UNITED STATES PATENT AND TRADEMARK OFFICE

APPLICATION NO.	FILING DATE	FIRST NAMED INVENTOR	ATTORNEY DOCKET NO.	CONFIRMATION NO.
10/750,341	12/31/2003	Christoph K. Hitzenger	ZEIS-2028	9461

Office Action Summary	Application No.	Applicant(s)	
	10/750,341	HITZENBERGER, CHRISTOPH K.	
	Examiner	Art Unit	
	Samuel A. Turner	2877

DETAILED ACTION

FIGURE 3

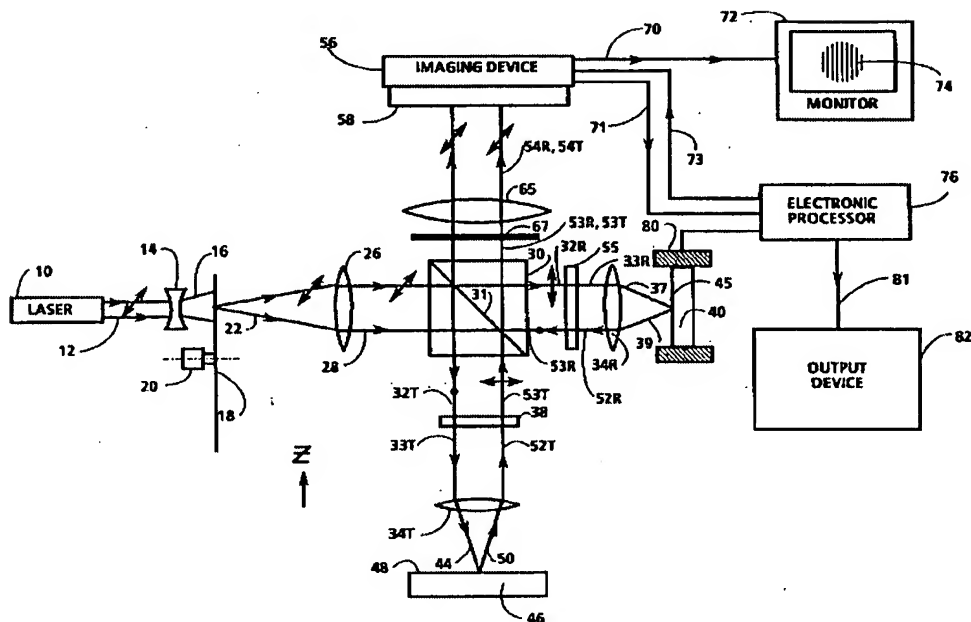
With regard to claim 1, Biegen teaches a interference surface profiler system comprising:

an interferometer (figure 3) having a reference arm (45, 55) and a sample arm (38, 48) each having an optical path, the sample arm being disposed such that a test sample (46) reflects a sample portion $R_s(52T)$ of an incident optical signal $S_s(33T)$ along the sample arm optical path;

a reflector (45) disposed in the reference arm to reflect a reference portion $R_R(52R)$ of an incident optical signal $S_R(33R)$ along the reference arm optical path;

a source (10, 18) for producing an optical source signal $S(28)$ having a short coherence length (column 4, line 68) and a first polarization state;

a polarizing beam splitter(30) disposed to direct portions of the optical source signal S along the reference arm optical path and the sample arm optical path;

a first polarizing element(67) disposed to select, from the returning reference and sample portions (R_R+R_S), a detector component $S_D(54R,54T)$ having a second polarization state; and

a detector(58) disposed to produce an output signal V_D representing the optical signal intensity I_D of the detector component S_D , wherein the second polarization state is related to the first polarization state such that the detector operates in a noise-optimized regime.

As to claim 10, wherein the interferometer is a Michelson interferometer(**figure 3**).

a second polarizing element(38) disposed in the sample arm optical path such that the returning sample portion R_S is directed by the polarizing beam splitter to the detector.

a second polarizing element(55) disposed in the reference arm optical path such that the returning reference portion R_R is directed by the polarizing beam splitter to the detector.

in the detector, a plurality of optical transducers(56) each disposed to produce an electrical signal responsive to the detector component S_D .

As to claim 15 wherein the second polarization state is related to the first polarization state(54R,54T) such that the detector operates in a shot-noise limited regime.

FIG. 1A

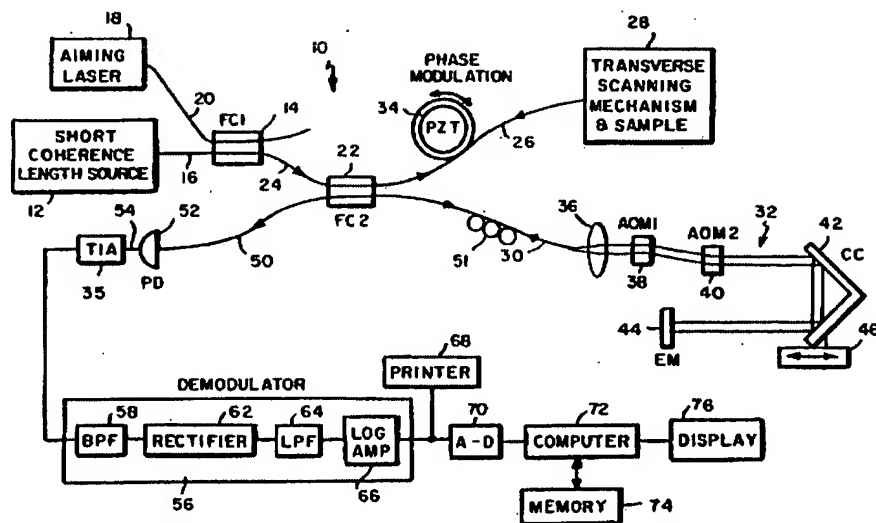
As to claims 9 and 25, Biegen teaches moving the reflector along the reference arm optical path by (column 8, lines 31-36) a reflector motor (80) disposed to move the reflector (45) along the reference arm optical path. Biegen however fails to teach any form of surface scanning.

Swanson teaches a transverse scanning mechanism 28 positioned in the measurement arm in order to scan the entire area of interest.

It would have been obvious to one of ordinary skill in the art at the time the invention was made to modify the apparatus of Biegen by including a transverse scanning mechanism either in the measurement arm or in the stage which holds the sample in order to profile samples larger than the image size of the interferometer.
